# CITY OF CANNON BEACH

## **WATER RESILIENCY PHASE 1 – SEISMIC IMPROVEMENTS**

### **ADDENDUM TO ITB - 2**

# ENGINEERING PLANS - ADDENDUM 2

C104

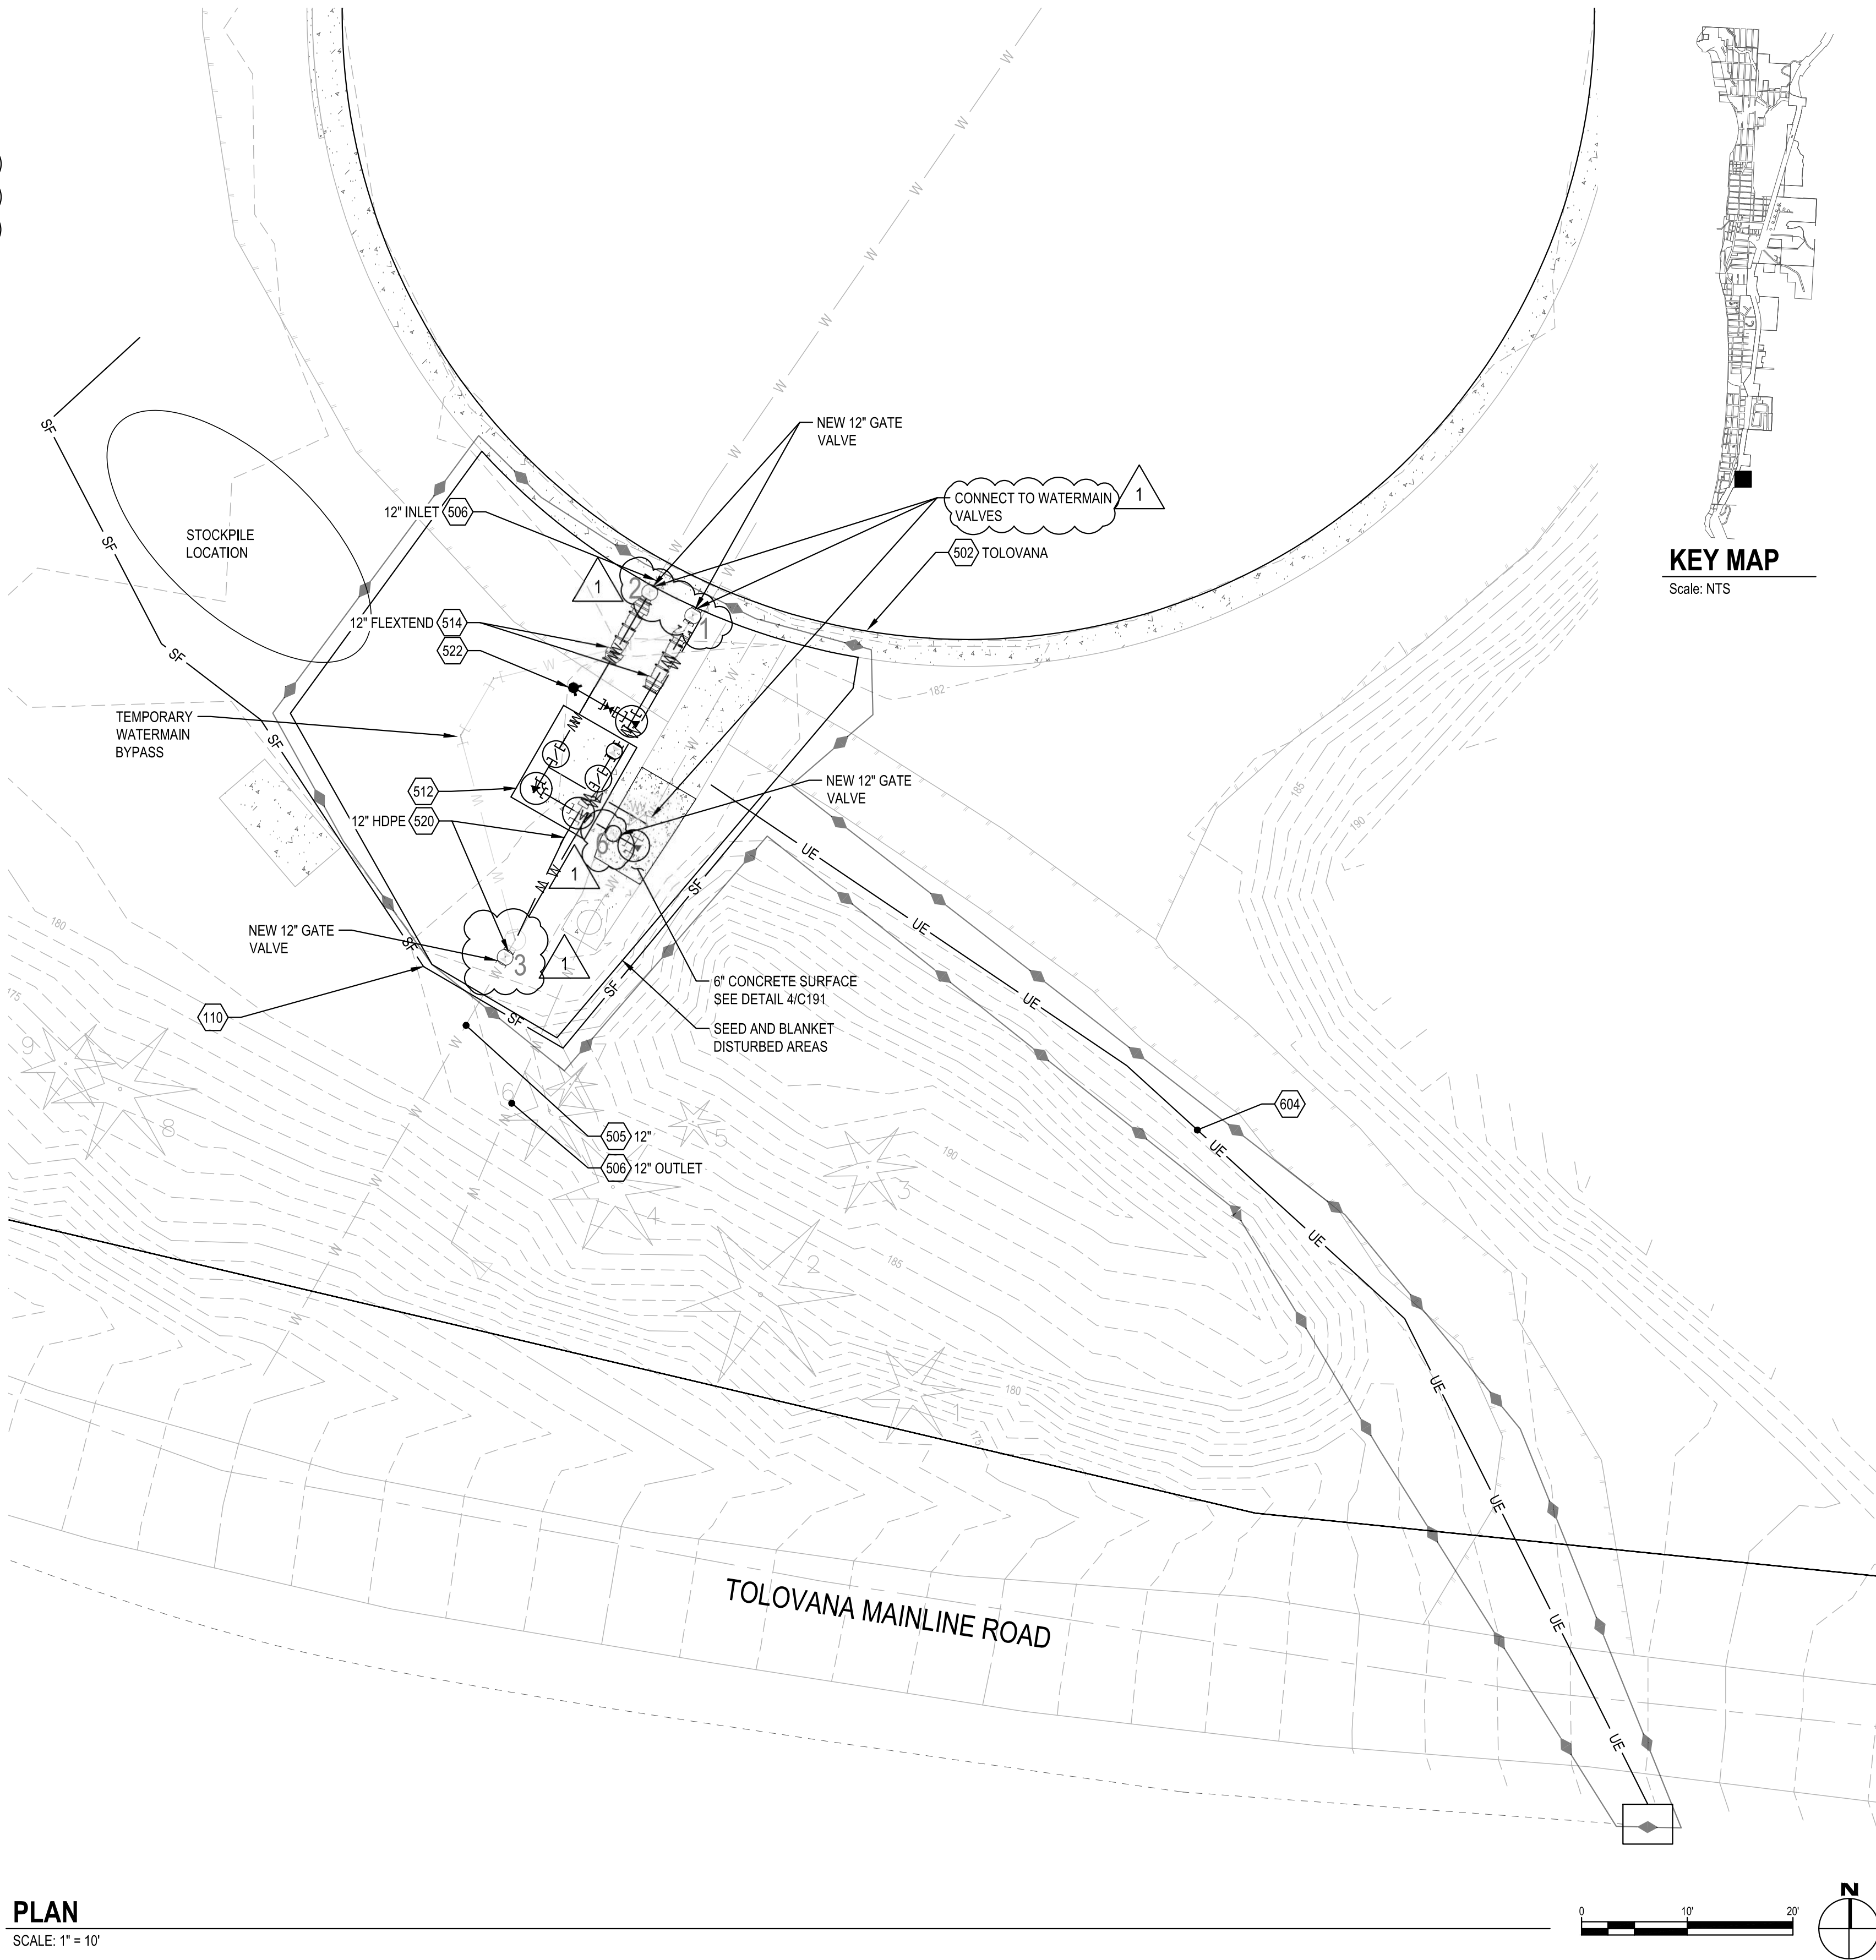
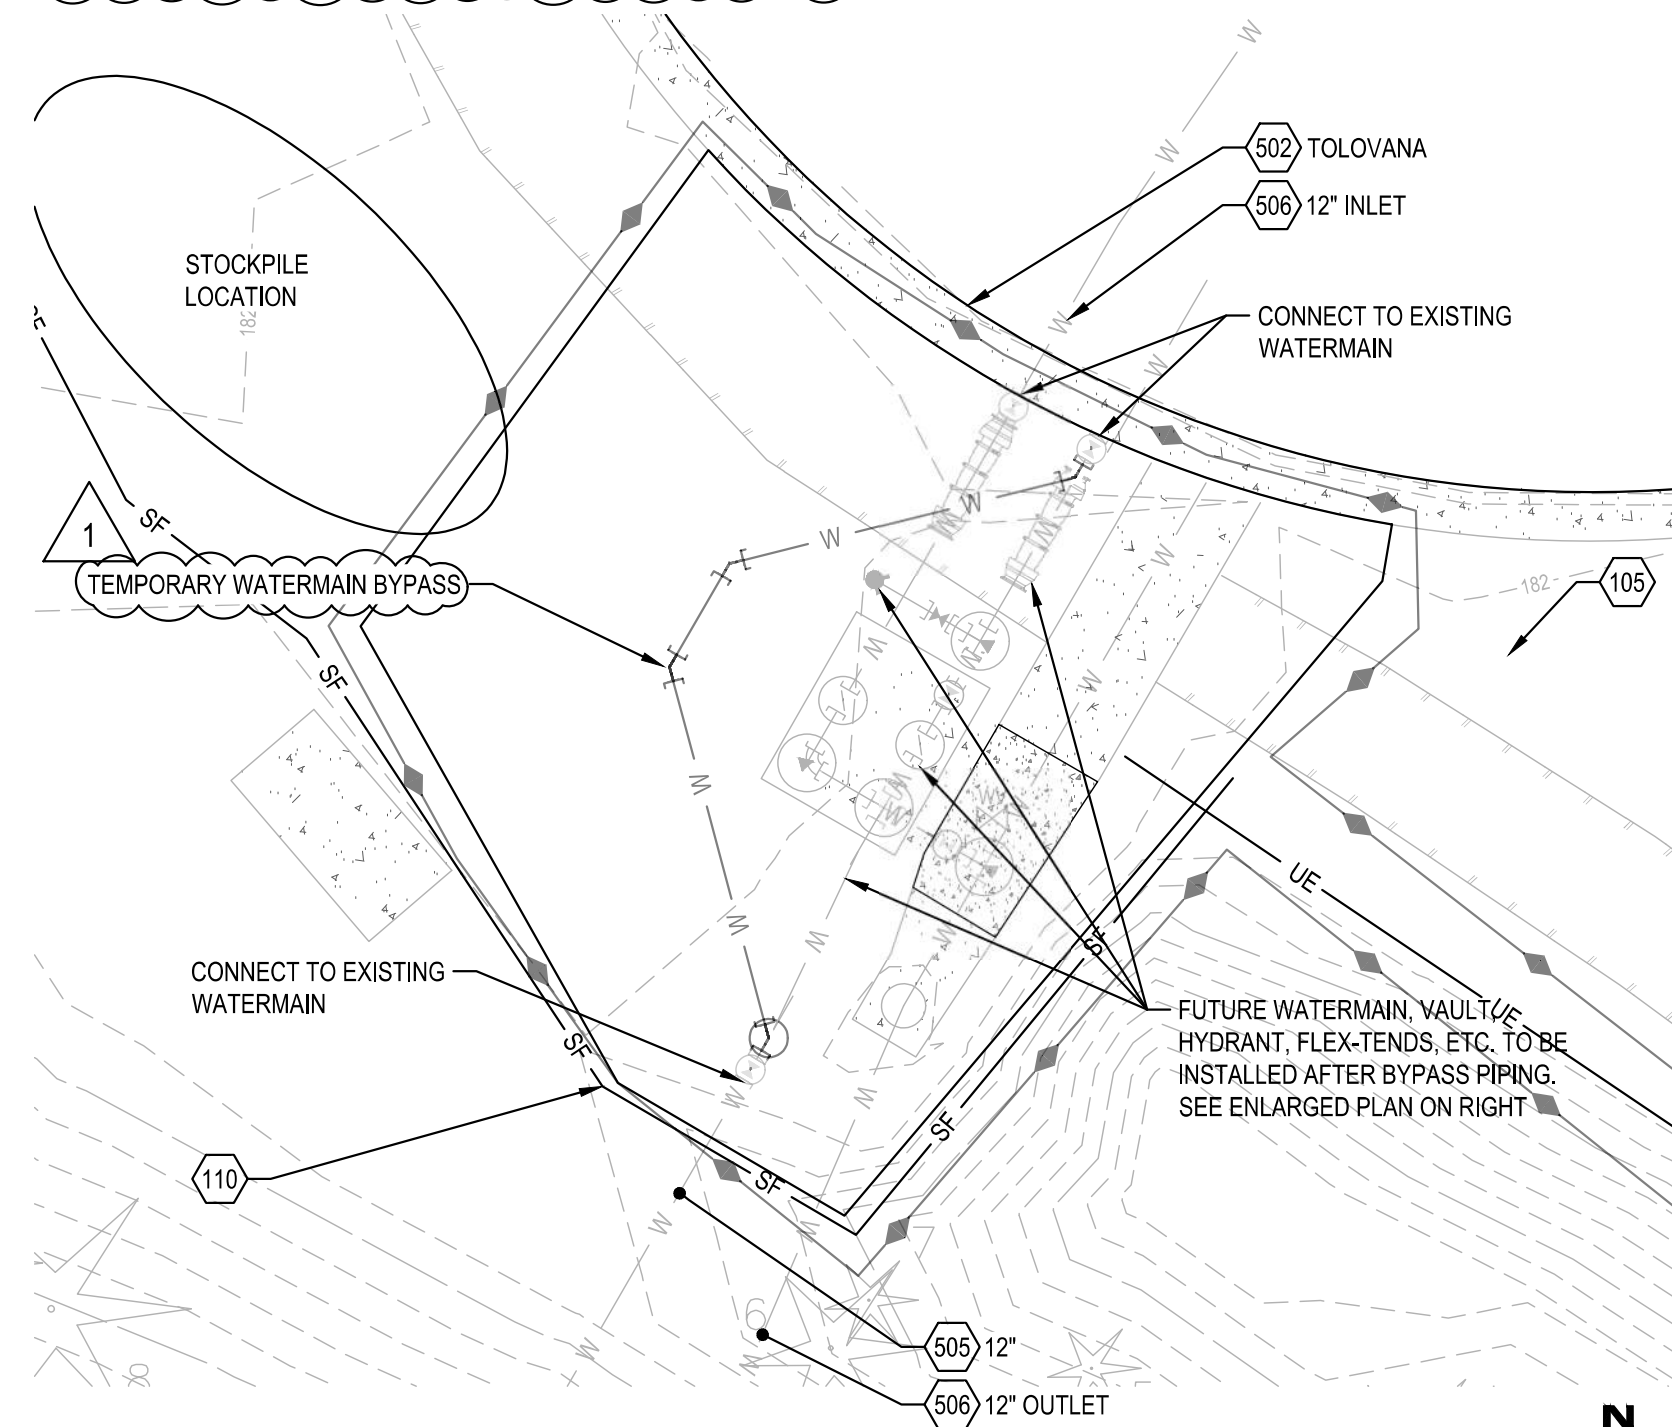
6. Plan Sheet – C104
  - a. Added general note “all construction related signage shall be installed at the city’s public works yard.”
  - b. Revised south reservoir shutdown notes.

- c. Added (now optional) temporary bypass notes.
  - d. Estimated quantities revised.
    - i. Connect to existing main = 1
    - ii. 12” Gate valve with actuator = 1

- e. Clarified that the 12” gate valves shown on the plan sheet are new and shall be furnished and installed regardless of whether the temporary bypass is used or not.

- i. Added valve numbers to correlate with the tank shutdown and draining notes.
7. Plan Sheet – C105
  - a. Removed the 12” gate valve with actuator located on the inlet pipe – Detail 3.

- TEMPORARY BYPASS IS OPTIONAL.
- THE BYPASS ALLOWS THE CONTRACTOR A LONGER WORKING TIME FRAME TO INSTALL THE VAULT, VALVES, ACTUATOR, AND PIPES THEN THE PROPOSED 2 WEEK SHUTDOWN TIME FRAME AT THE SOUTH RESERVOIR.
- SEE SHEET C105 FOR ADDITION TEMPORARY BYPASS INFORMATION, DESIGN AND CONTRACTIBILITY OF THE BYPASS IS THE RESPONSIBILITY OF THE CONTRACTOR.

- PROVIDE THE CITY ONE WEEK NOTICE BEFORE REQUIRING WATER SHUTDOWN TO PERFORM WORK.
- CITY WILL DRAIN THE SOUTH RESERVOIR PRIOR TO THE SHUTDOWN PERIOD.
- TANK MAY REMAIN OFFLINE FOR 2 WEEKS.
- INSTALLATION OF VALVE 3 REQUIRED WITHIN 48 HOURS TO BE ABLE TO SUPPLY WATER TO TWO RESIDENTS.
- IF TEMPORARY BYPASS OPTION IS USED IT SHALL BE INSTALLED BEFORE FEBRUARY 23RD.
- TANK WILL ONLY BE DRAINED ONCE. USE OF VALVES 1-3 WILL BE USED TO SHUTOFF WATER IN THE WORK AREA FOR ANY FUTURE OR UNFINISHED WORK.
- SEE SHEET C105 FOR ADDITION RESERVOIR INFORMATION.

E101

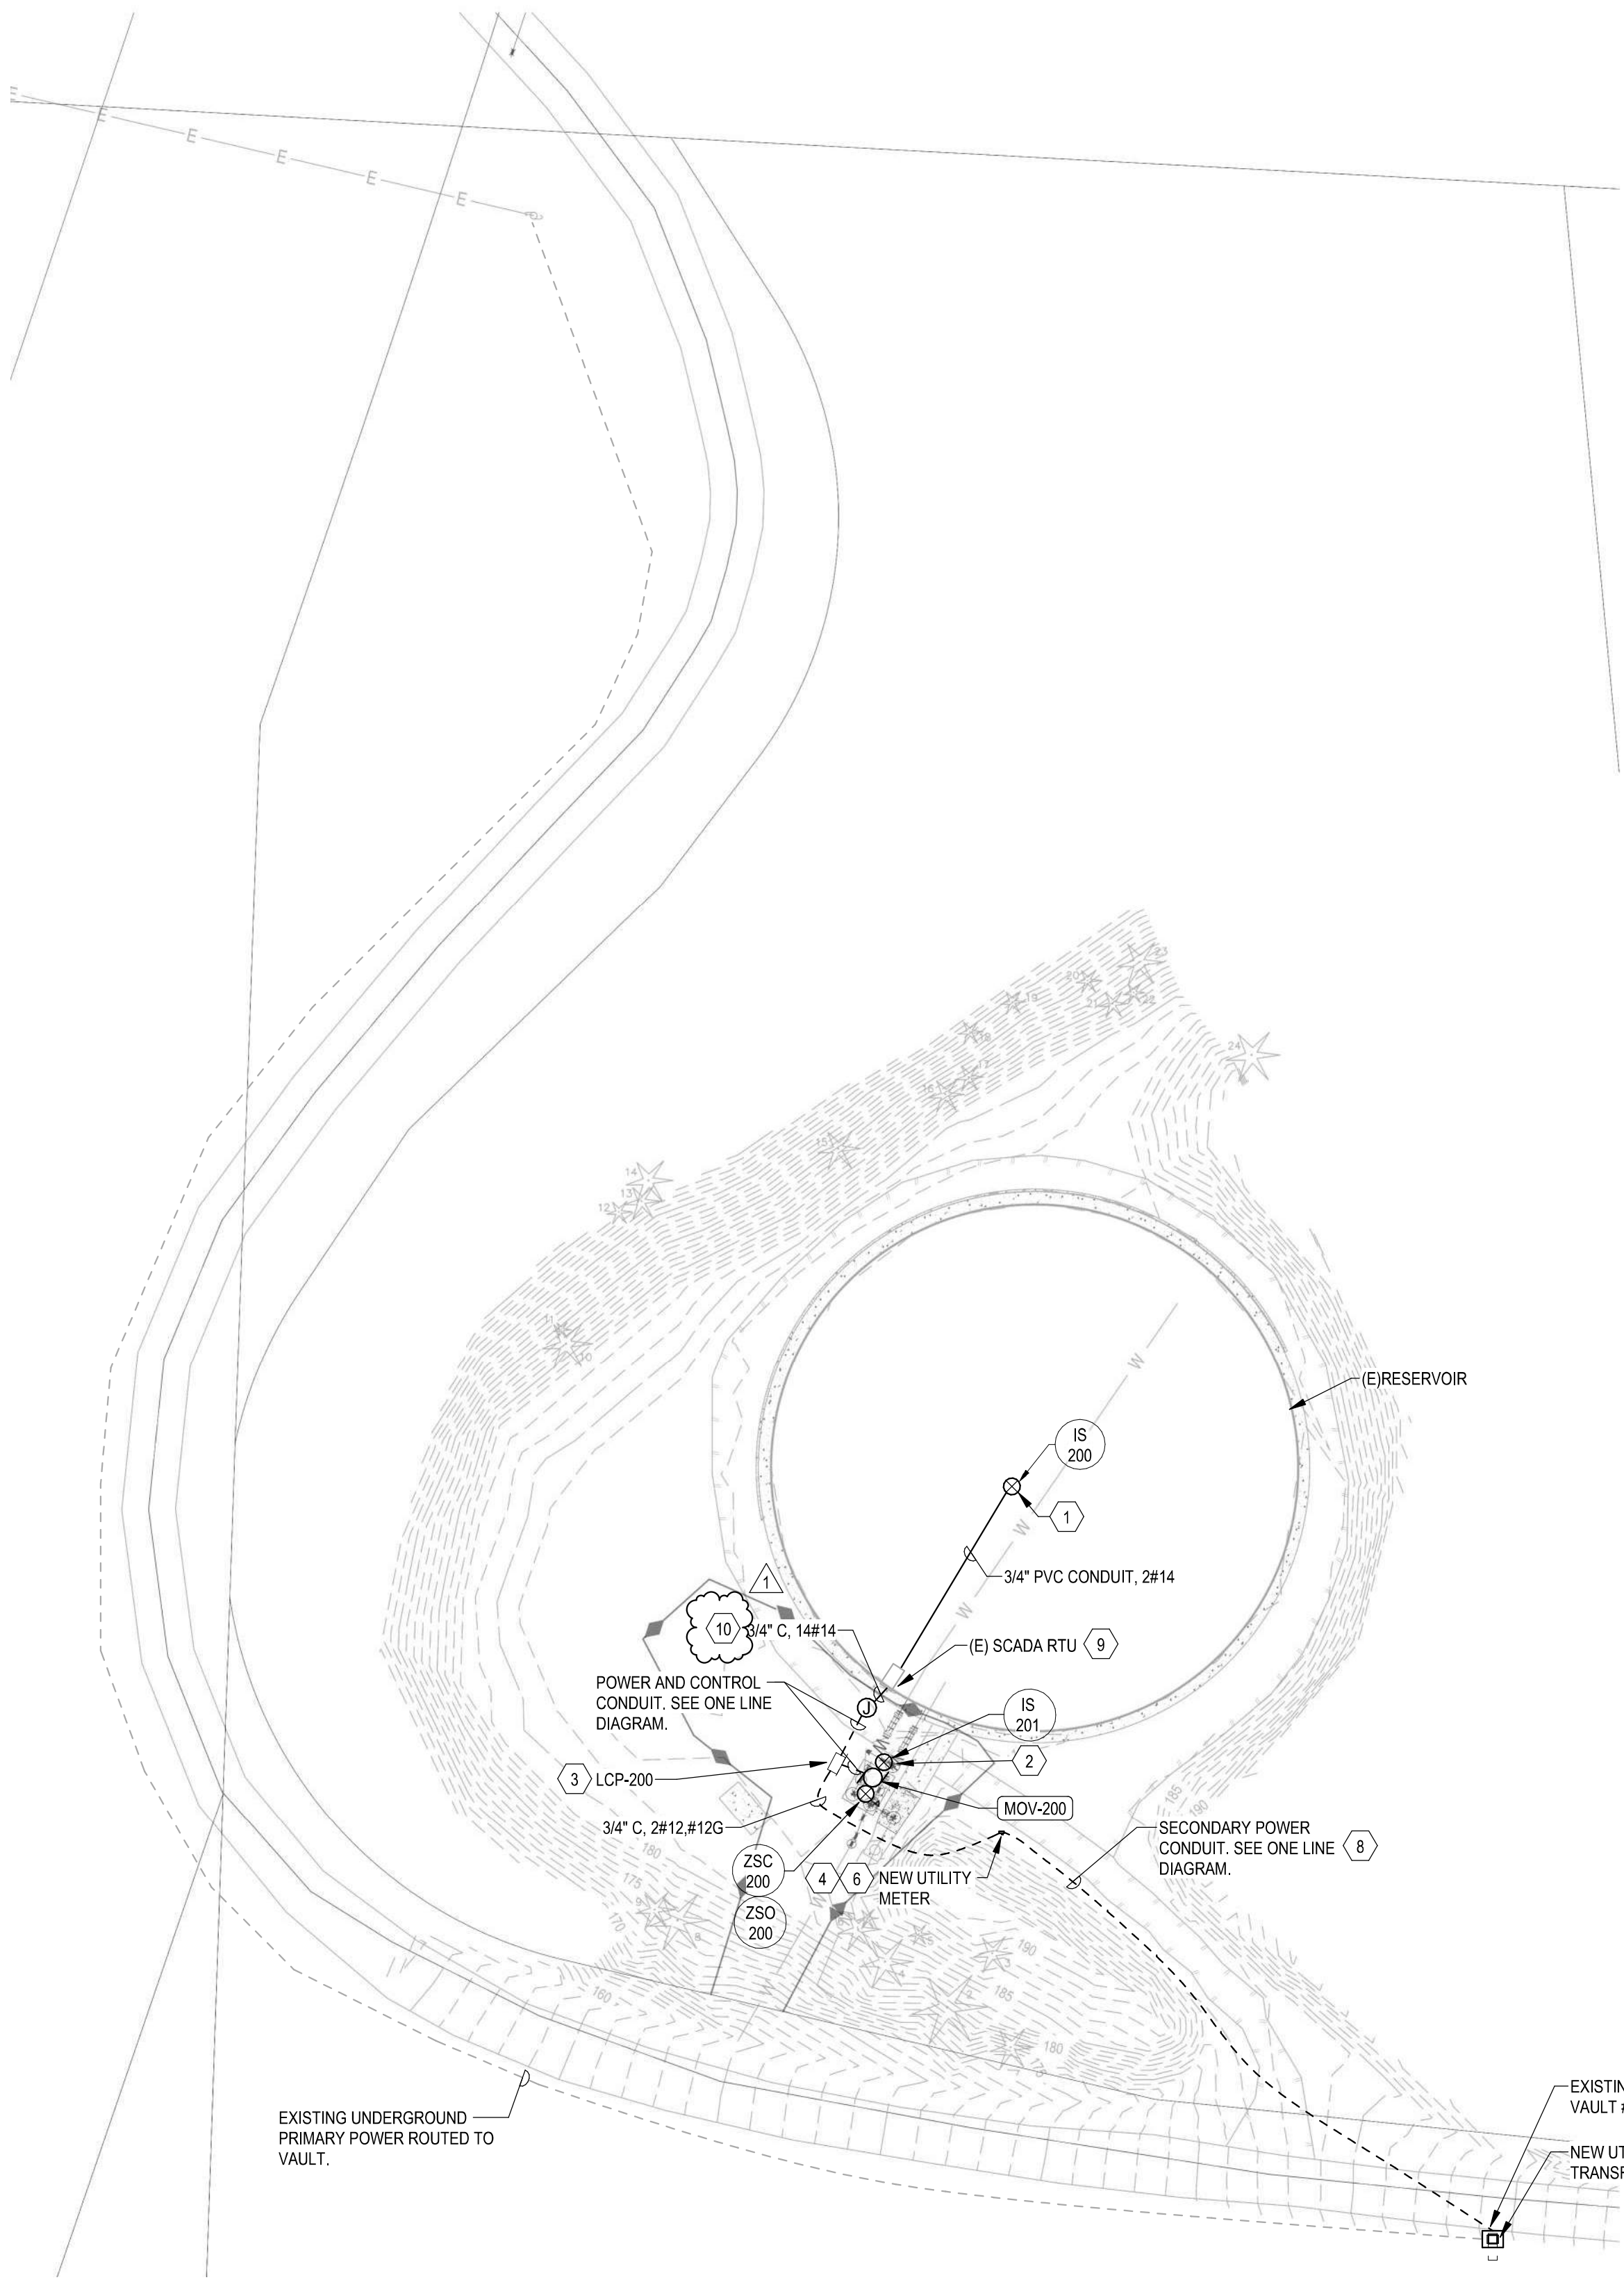
8. Plan Sheet E101
  - a. Added keynote 10 “provide 1-5/8” galvanized unistrut secured to existing ladder, ladder supports and concrete at base of tank. secure 3/4” conduit routed to RTU to unistrut with dielectric spacers and galvanized conduit straps.”

10 PROVIDE 1-5/8" GALVANIZED UNISTRUT SECURED TO EXISTING LADDER, LADDER SUPPORTS AND CONCRETE AT BASE OF TANK. SECURE 3/4" CONDUIT ROUTED TO RTU TO UNISTRUT WITH DIELECTRIC SPACERS AND GALVANIZED CONDUIT STRAPS.
